Near-term Task Force Recommendation 2.1 Seismic Hazard Evaluation

NTTF Recommendation 2.1- Summary of Preliminary Seismic Hazard Analysis: Indian Point Units 2 and 3

Summary of Issues

Complex Sub-surface Geology

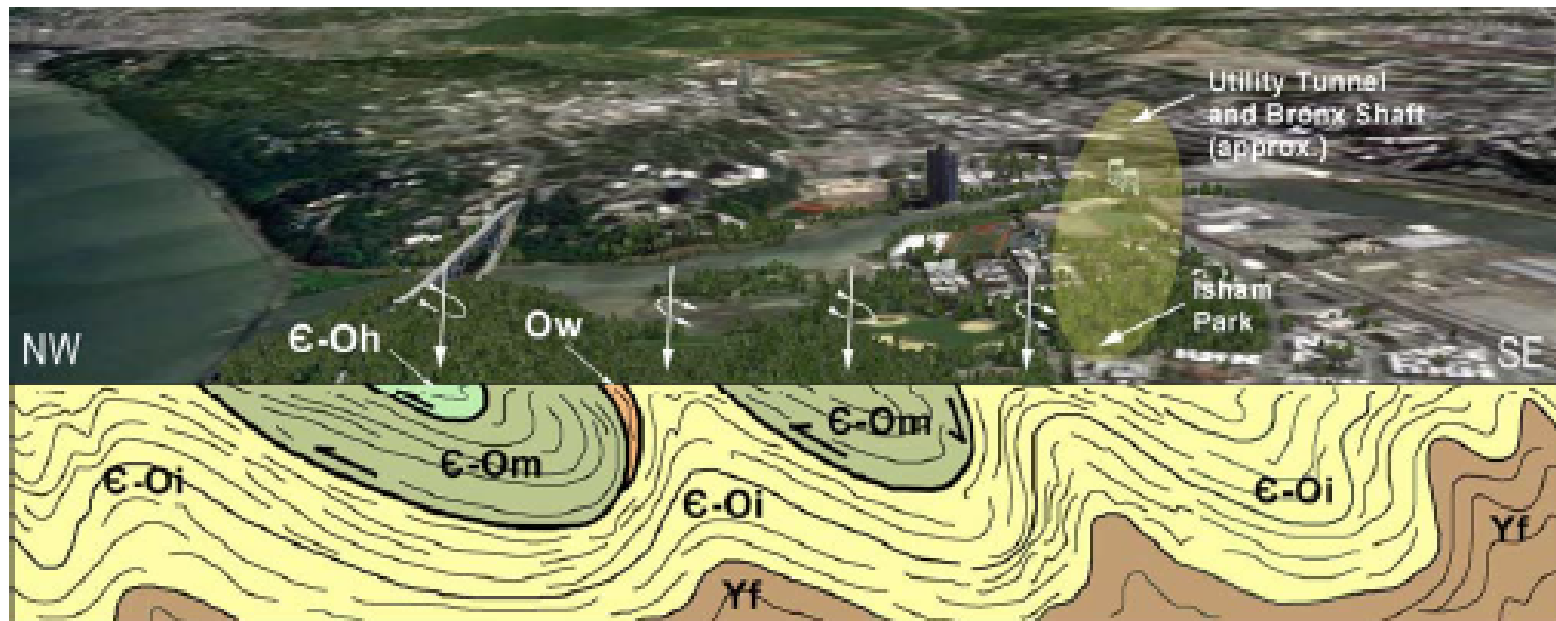
Geologic section of Inwood in Upper Manhattan (type section)

Based on regional observations: assume that the Cambrian Quartzite
And underlying units have a $V_s > V_s$ reference

ADVANCED GEOLOGICAL SERVICES	SHEAR WAVE VELOCITY PROFILE ReMi RESULTS INDIAN POINT POWER PLANT	
	LOCATION: BUCHANAN, NEW YORK	
PROJECT #: 06-245-1	CLIENT: GZA GEOENVIRONMENTAL	FIGURE 8A
DATE: SEPTEMBER 20, 2006	DATE: 8/11/06	DRAWN BY: 8/11/06

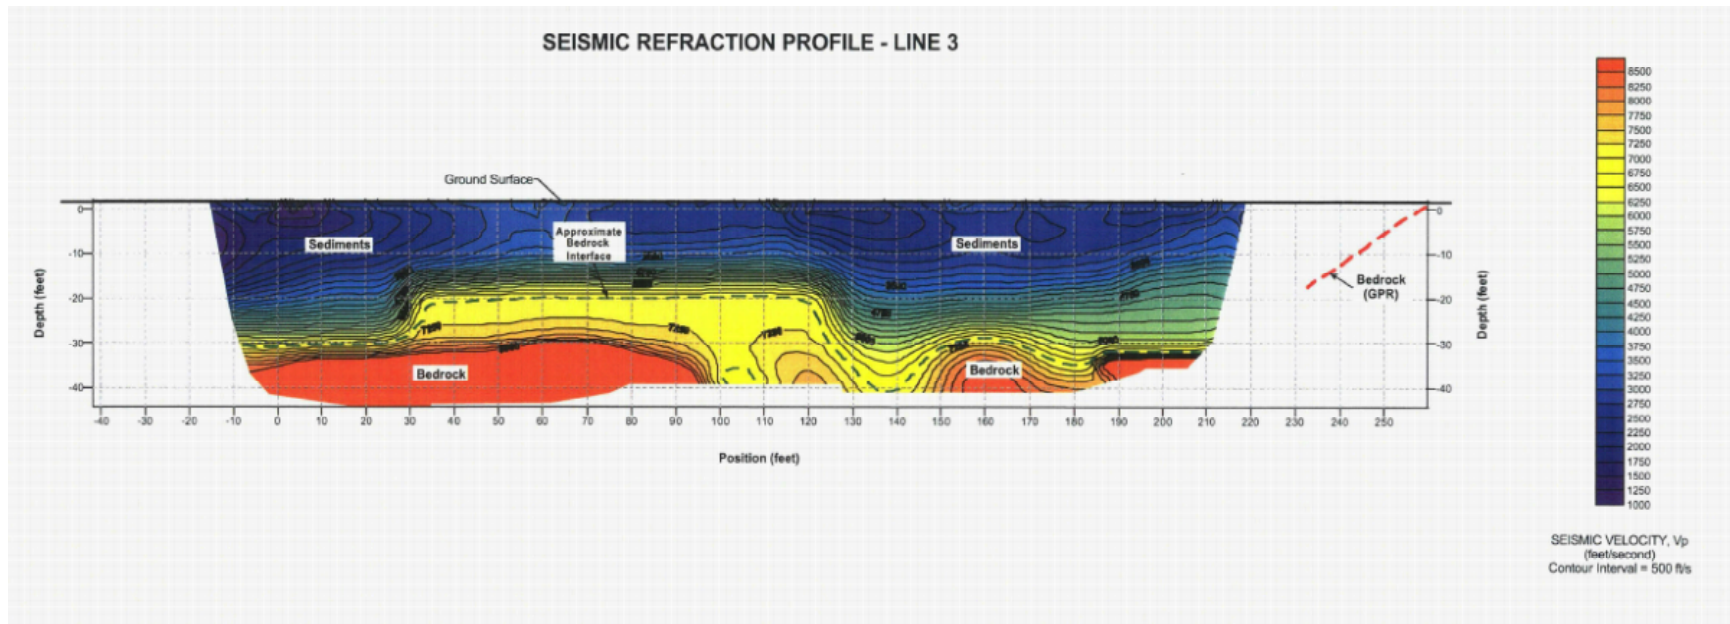
Shear-wave velocity profile
from IP site.

13 profiles acquired with
Surface wave-technique-
All penetrated bedrock

Very consistent velocities
in upper portion of
bedrock (Inwood)

GZA Report: Seismic Profiles

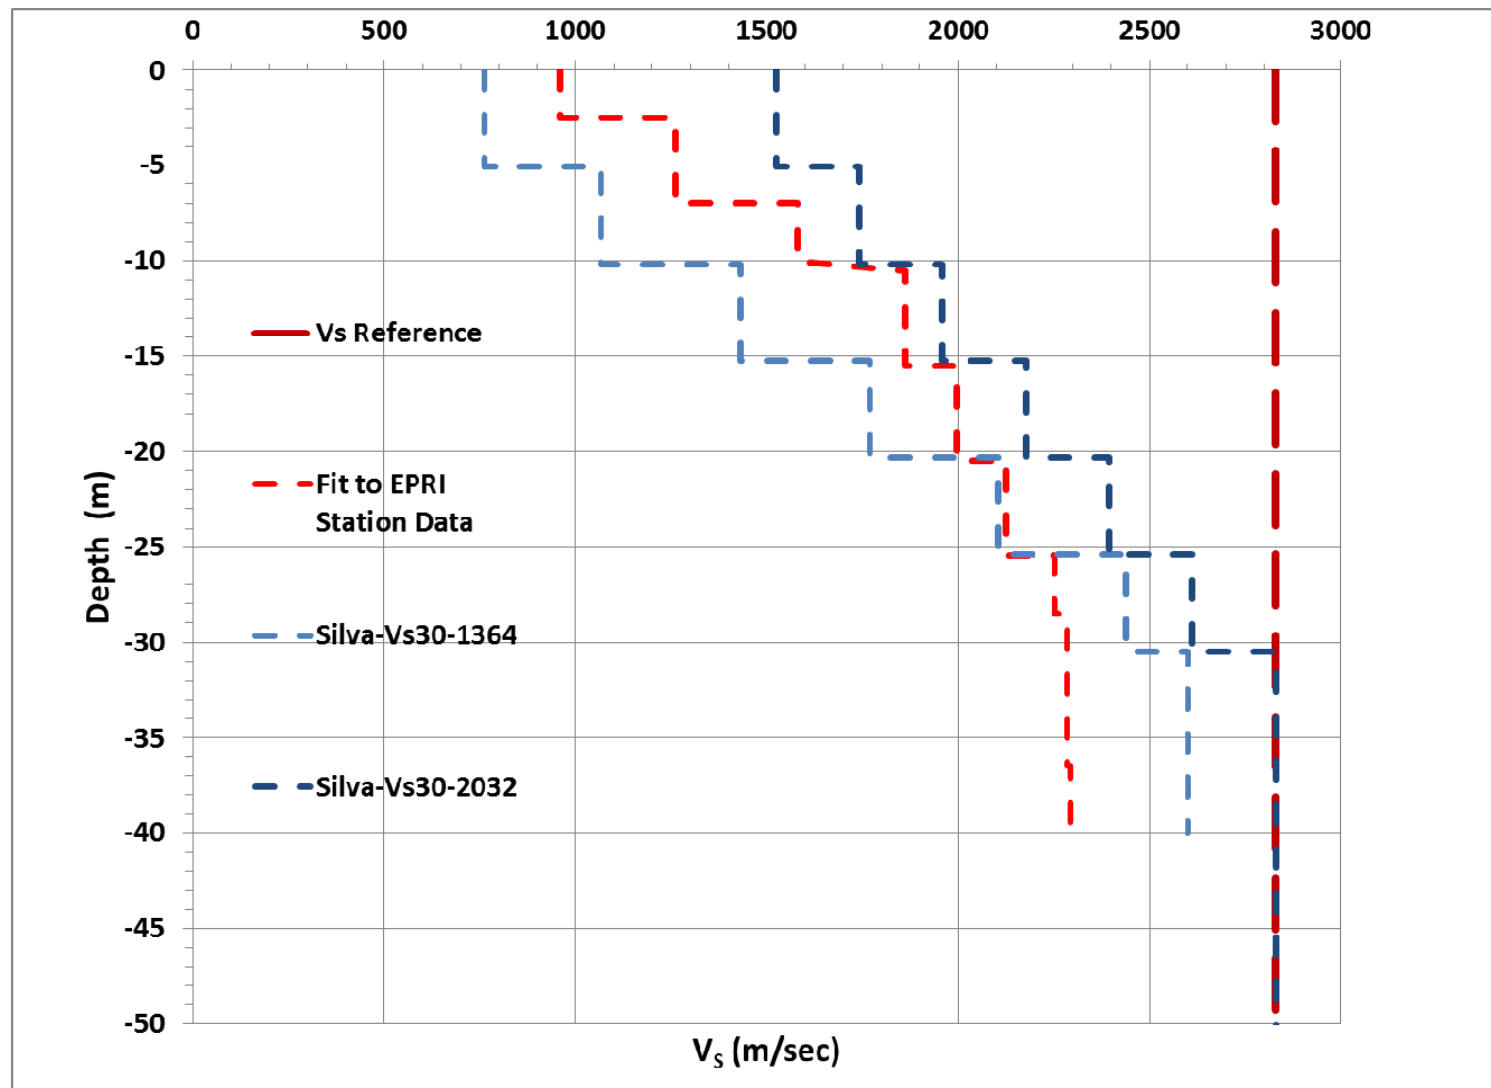
Independent P-wave data indicates $V_p \sim 8-9000$ fps in near surface.

IP Velocity Profiles Informed with Template Profiles

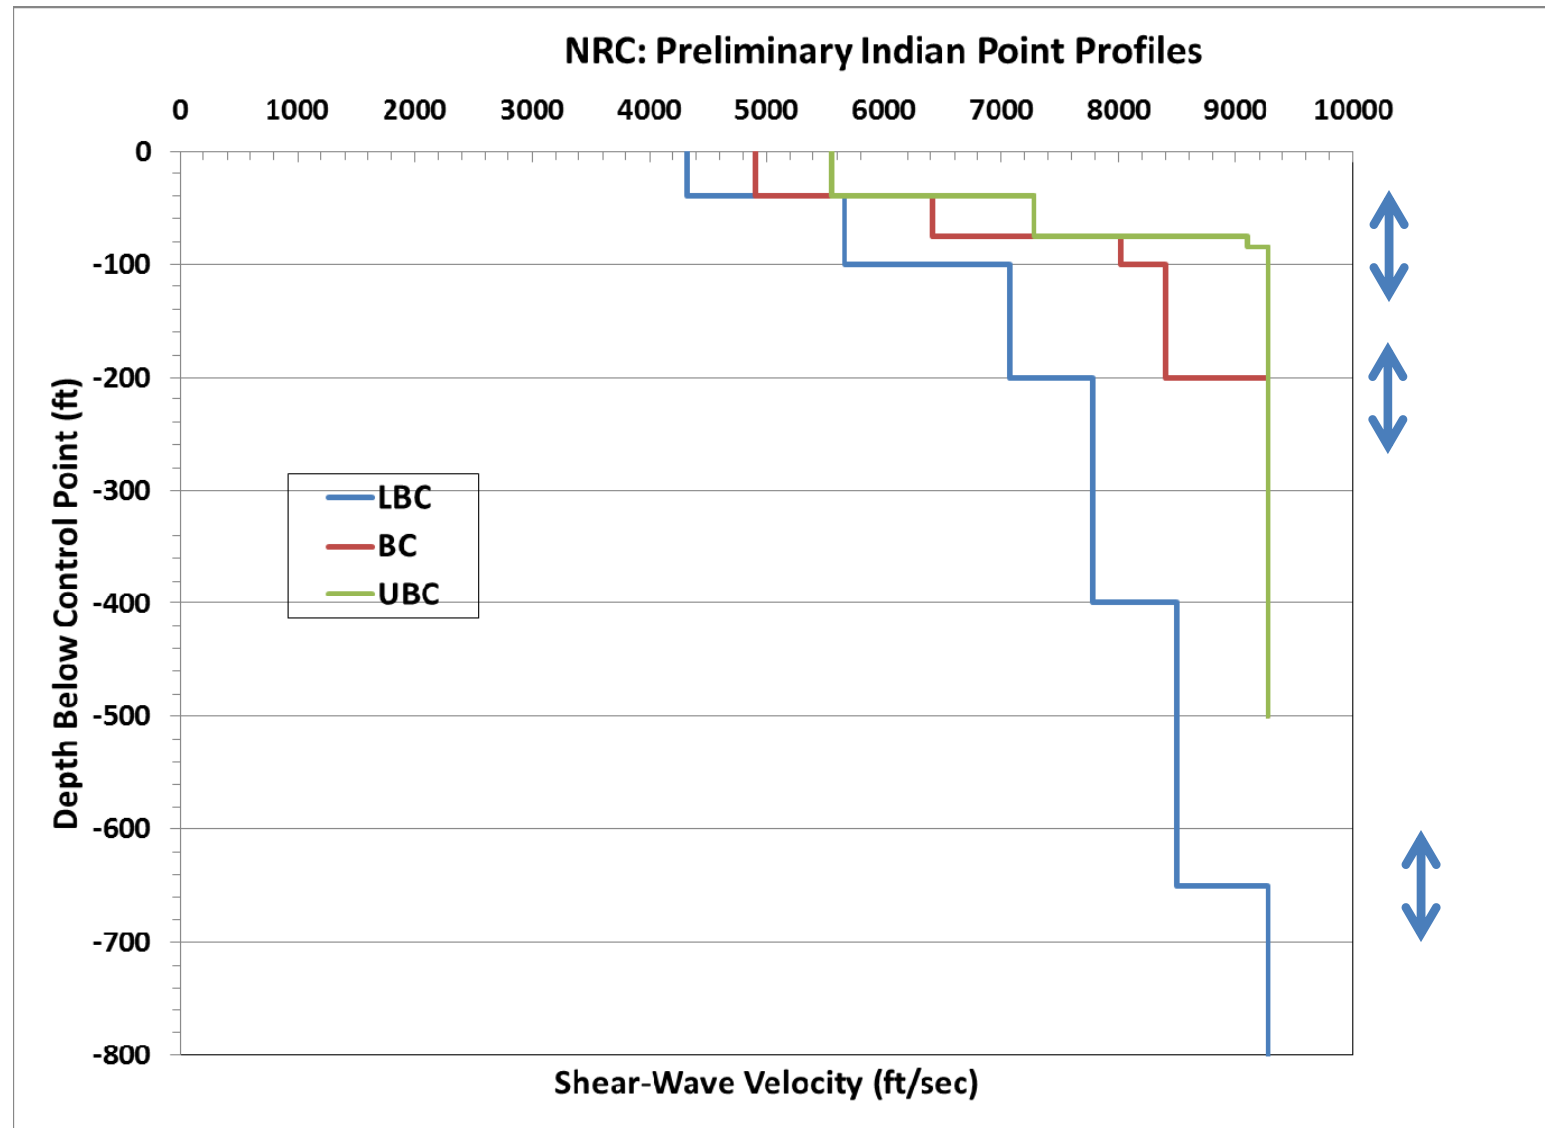
Profiles Used in NRC Analysis

Preliminary Indian Point Site Response Model

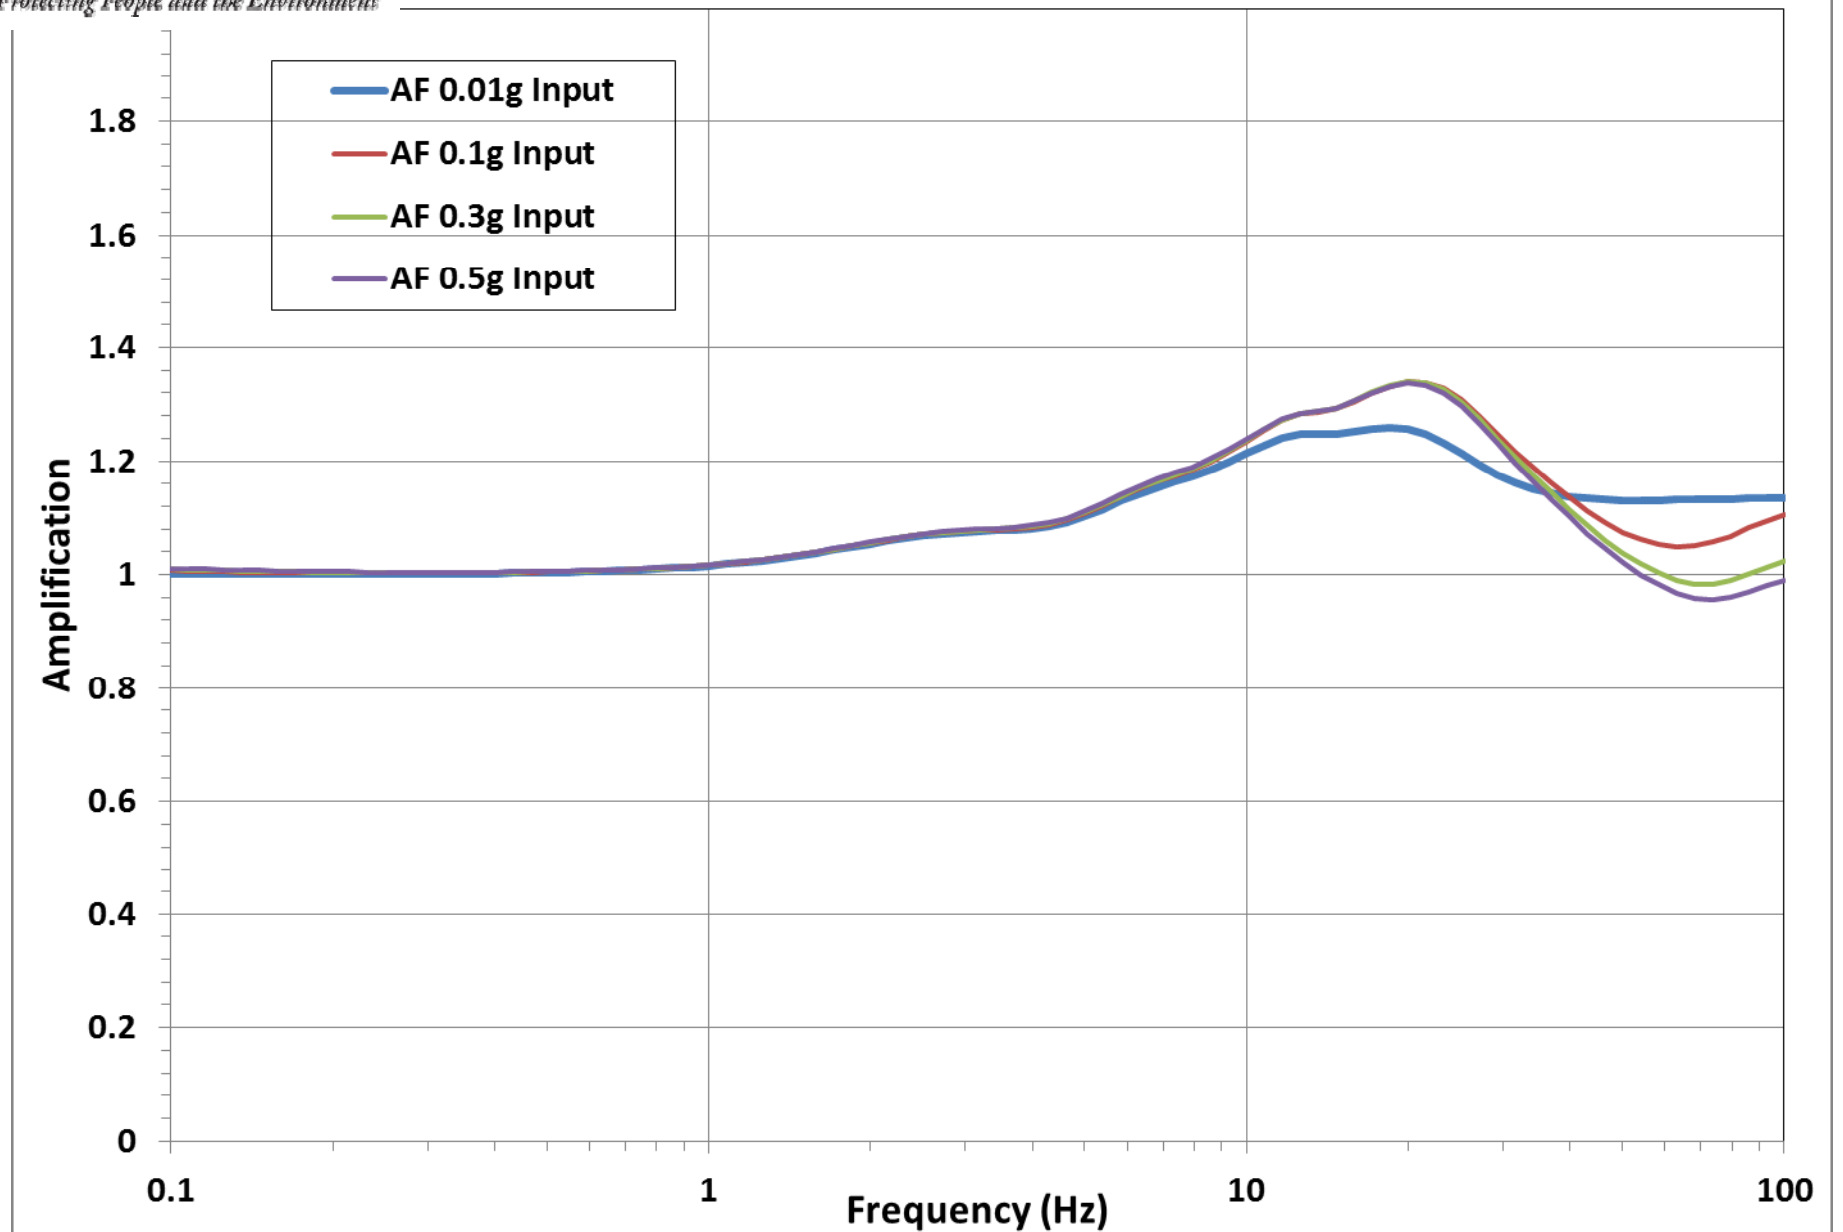
Layer	Depth (ft)	Velocity (ft/s)	Sigma-In (Vs)	G/Gmax&D	G/Gmax&D
BC-1	0-40	4900	0.15	EPRI Rock	Linear-1%
BC-2	40-75	6419	0.15	EPRI Rock	Linear-1%
BC-3	75-100	8024	0.15	EPRI Rock	Linear-1%
BC-4	100-200	8400	0.15	Linear-ND	Linear-ND
LBC-1	0-40	4320	0.15	EPRI Rock	Linear-1%
LBC-2	40-100	5662	0.15	EPRI Rock	Linear-1%
LBC-3	100-200	7077	0.15	EPRI Rock	Linear-1%
LBC-3	200-400	7785	0.15	Linear-ND	Linear-ND
LBC-4	400-800	8500	0.15	Linear-ND	Linear-ND
UBC-1	0-40	5555	0.15	EPRI Rock	Linear-1%
UBC-2	40-75	7277	0.15	EPRI Rock	Linear-1%
UBC-3	75-85	9000	0.10	EPRI Rock	Linear-1%
